From: <tfohara@dukeengineering.com>
To: Goutam Bagchi <GXB1@nrc.gov>
Date: Wed, Mar 29, 2000 4:10 PM
Subject: Some thoughts on draft technical document & truncation

Comments on NRC "Draft Final Technical Study of Spent Fuel Pool Accident Risk at Decommissioning Plants" – February 15,2000**Summary of NRC Draft**

Comments on Appendix 2b Structural Integrity of Spent Fuel Pools Subject to Seismic Loads (Reference 1)1. Introduction

Figure 1 – Distribution of Upper Bound Magnitude Estimates from Reference 1 for a New England site.

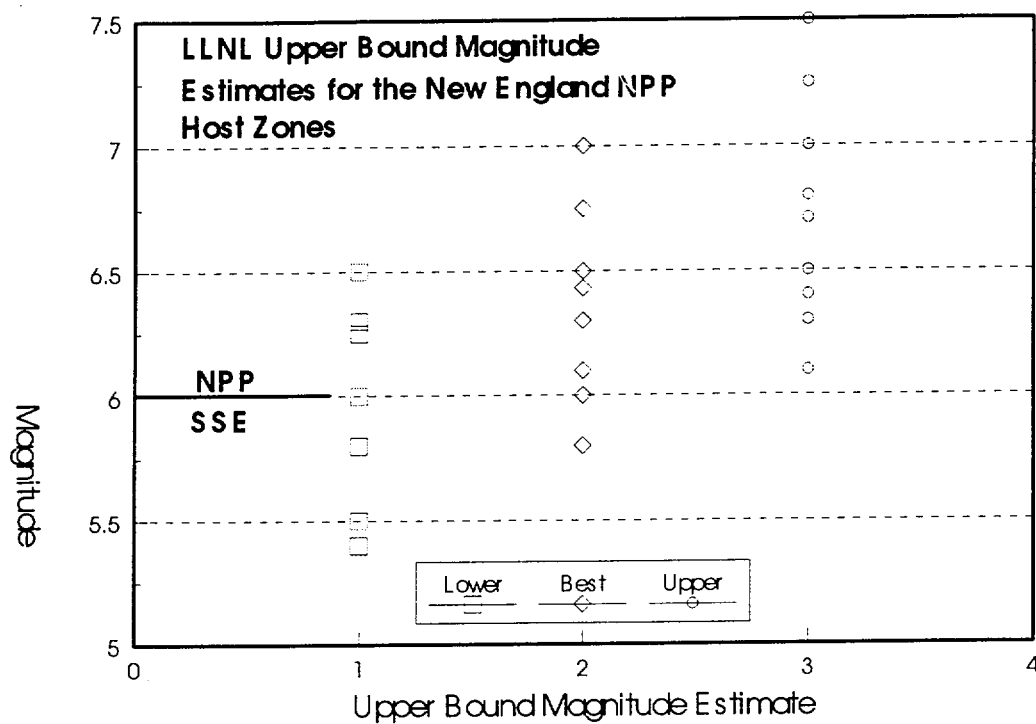
the assumption of the largest event geophysically ascribable to a tectonic province or to a capable structure at the closest proximity of the province or fault to the site. In the case of the tectonic province in which the site is located, the event is assumed to occur at the site. For the Eastern seaboard, the Charleston event is the largest magnitude earthquake and current research has established that such large events are confined to the Charleston region. The New Madrid zone is another zone in the Central US where very large events have occurred. Recent research has identified the source structures of these large New Madrid earthquakes. Both of these earthquake sources are fully accounted for in the assessment of the SSE for currently licensed NPPs. The SSE ground motions for NPPs are based on conservative estimates of the ground motion from the largest earthquake estimate to be generated from the current tectonic regime. For CEUS sites the typical NPP is designed for about a magnitude 5.3 to 5.5 (about 0.15g). The largest design basis earthquake for a CEUS site, based on detailed seismological, geological, and geophysical investigations, is magnitude 6.0 (about 0.25g). In no EUS licensing proceeding has there been compelling data to require design to an earthquake of a magnitude which would challenge the seismic capacity of an SFP that satisfies the seismic checklist. For WUS sites the design basis ground motion is generally governed by known active faults at known distances. Based on fault length and other deterministic factors the maximum earthquake potential can be estimated.

Figure 2 Effect of Attenuation Random Uncertainty on Probability of Exceedance from a Point Source

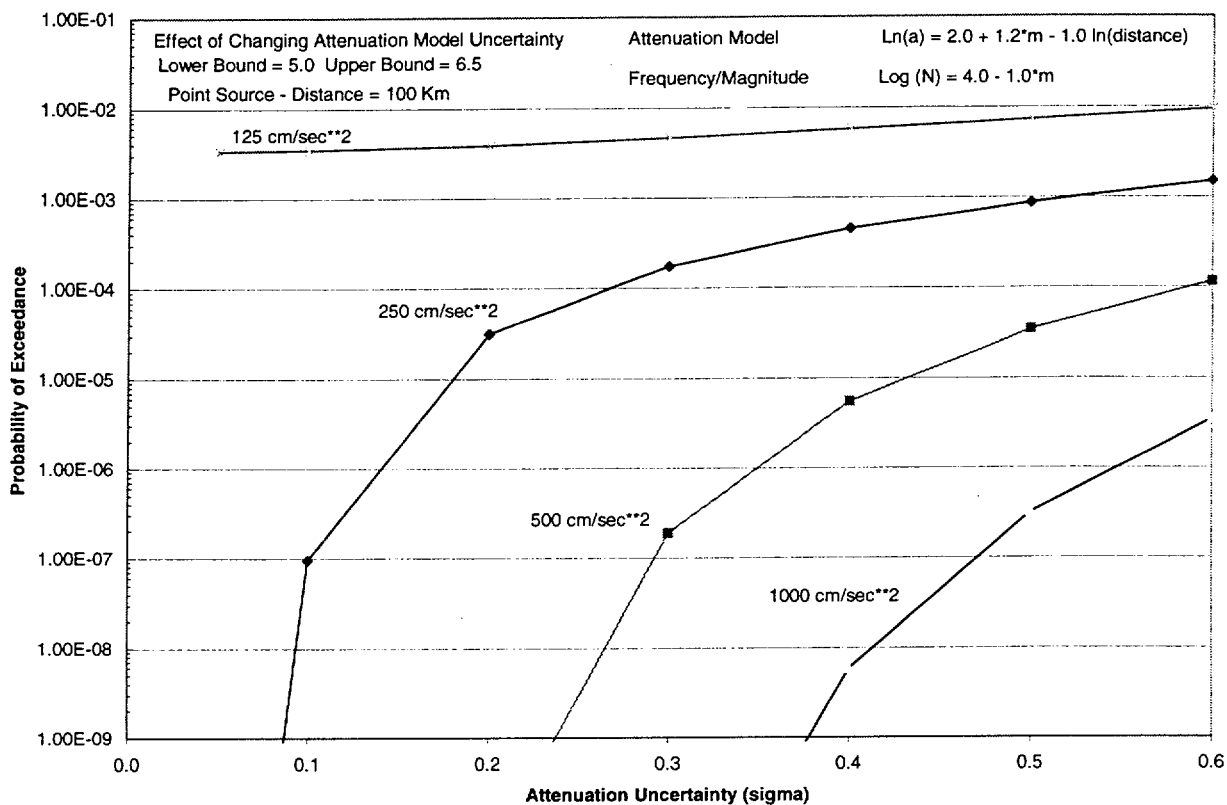
Goutam - attached are some comments on the draft technical document. Included in the text is a discussion on the effect of the attenuation model random uncertainty term. I was able to analytically model a point source and show the effect of how changes in sigma change the probability of exceedance at various ground motion levels. The bottom line is that at high ground motions, the probability of exceedance is driven by the extreme tail of the distribution.

It was noted previously that a 0.5g HCLPF relates to about a 1 g median SFP capacity. When rigorously convolving a typical mean seismic hazard curve with the SFP fragility curve associated with a 0.5g HCLPF, the dominant contribution to the seismic risk occur above about 0.7g. Based on this information, only large earthquakes can generate ground motions of the amplitude, frequency content, and duration to challenge the seismic capacity of spent fuel pools. However, at high ground motion values (1g), the tail of the attenuation random uncertainty distribution (sigma) allows, with some non-negligible probability, relatively small events to contribute to the probability of exceeding a ground motion of 1g. Deterministic evaluation performed in the licensing of CEUS NPPs have not identified any sources near NPPs that are capable of generating earthquake ground motions of this magnitude. Therefore, these probabilistic results don't make sense and provide a basis for truncating the tail of the random uncertainty term at high ground motion values or using a smaller value for the random uncertainty term at high ground motions.

Figure 3 – Annual Probability of Exceeding the SSE at CEUS sites based on EPRI (Reference 3)

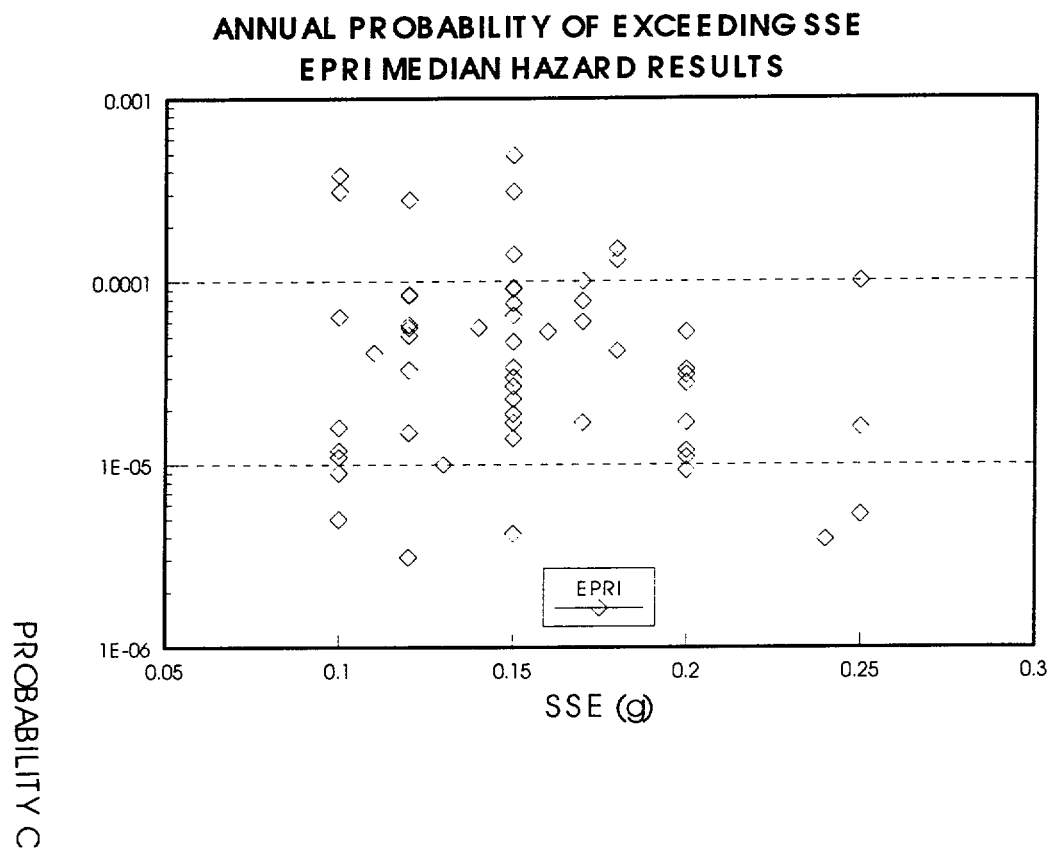
earthquakes to the overall seismic hazard, not on the absolute effect. Also, comparisons between the LLNL and EPRI results was typically made at the SSE level (0.15g to 0.25g - annual probability of 10^{-3} to 10^{-4}), not at the ground motion level associated with a HCLPF of 0.5g. It is noted that given a HCLPF of 0.5g the median capacity (A_m) of an SFP is about 1.0g ($A_m = \text{HCLPF}/e^{-1.65(B_c)}$) – far from typical SSE values. Realistically, only large Charleston like earthquakes can generate ground motions of the amplitude, frequency content, and duration to challenge the seismic capacity of spent fuel pools. However, at high ground motion values (1000 cm/sec²), the tail of the attenuation random uncertainty distribution (sigma) allows, with some non-negligible probability, relatively small events to contribute to the probability of exceeding a ground motion of 1000 cm/sec². Figure 2 shows the effect of changing sigma for a point source at a given distance. These results were analytically determined. As can be seen, at low ground motions (125 cm/sec²), changes in sigma have a small effect on the probability of exceedance. However, at high accelerations (1000 cm/sec²) the effect of changes in sigma is profound. The high probability of exceeding 1000 cm/sec² based on use of a sigma of 0.6g in Figure 2, is driven by the tail of the attenuation random uncertainty term. For example, 1000 cm/sec² is about 3 standard deviations above the expected ground motion from a magnitude 6.5 earthquake at 100 km. Deterministically, these results don't make sense and provide a basis for truncating the tail of the random uncertainty term at high ground motion values. Use of a smaller sigma value is a form of truncation. As can be seen on Figure 2, the probability of exceeding 1000 cm/sec² is reduced by about a factor 600 by simply changing sigma from 0.6 to 0.4. EPRI results are based on use of a sigma of 0.5. Based on this information and information previously described in Reference 5, use of the LLNL probabilistic estimates at low probability values may not be credible. EPRI results are also likely to be overly conservative at high ground motion values.
